PRODUCT CHANGE NOTIFICATION: PCN250109

Change Overview:

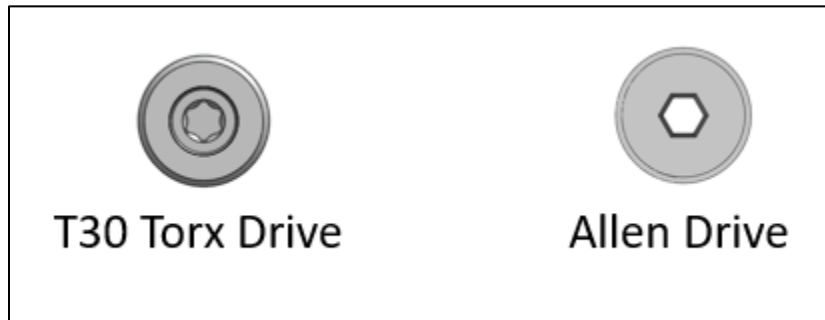
This communication is a notice of a change to Roll-Rite fasteners that are used to attach the 30°, 45° offsets & 90° elbows. Effective December 25th, 2024, Roll-Rite will begin the process of changing the fastener that is used in all the arm offsets and 90° bow elbows. The updated fastener will require a T30 Torx bit whereas the older fastener requires an Allen wrench or Allen bit. Proper torque for the updated T30 drive fastener must be 68-75in lb. (7.6-8.4Nm)

Please review the images below of the updated design.

Updated Service Kits For 90° corners and 30° & 45° offset elbows (bow tube)

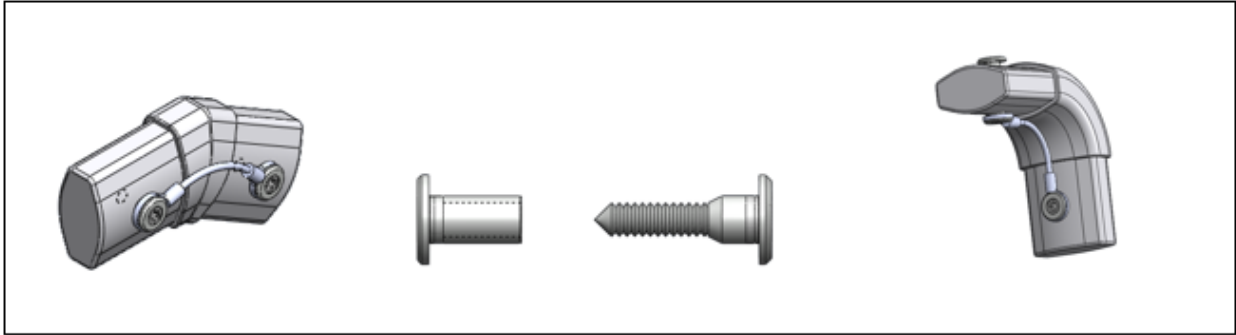
When ordering replacement fasteners for 90° corners and 30° & 45° offset elbows (bow tube), use service kit **108913**.

Installation of Barrel Bolts

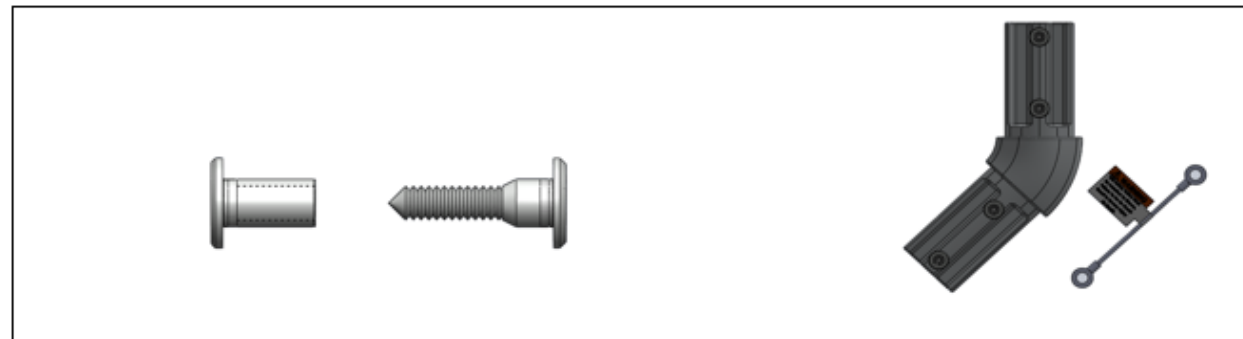
Tool Required: (2) T30 Wrenches

Torque Barrel Bolts to: 68-75 in-lb. (7.6- 8.4 Nm)

This Safety Tether Must Be Installed As Shown. Failure To Do So Could Result In Severe Injury Or Death
